Summary of Changes

Turkey Point Plant Radiological Emergency Plan , Revision 43

TURKEY POINT PLANT
RADIOLOGICAL
EMERGENCY PLAN
REVISION 43

Revision Approval Date: 10/4/05

FIGURE 5-1 (1 of 3)

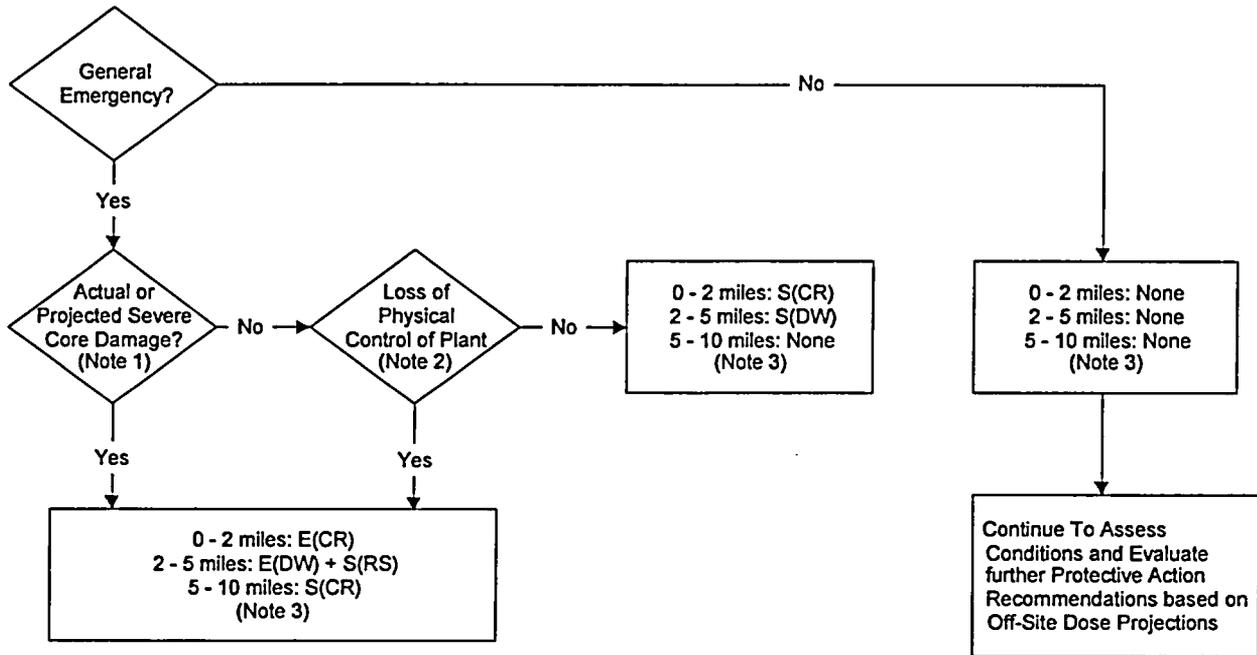
1. Revised the guidance for determining Protective Action Recommendations resulting from a radiological release lasting less than 2 hours as described in NRC RIS 2001-13, Consideration of Sheltering in Licensee's Range of PARs.
2. Updated Letters of Agreement with various offsite support agencies.

**Guidance for Determining Protective Action Recommendations (PARs)
Based on Plant Conditions**
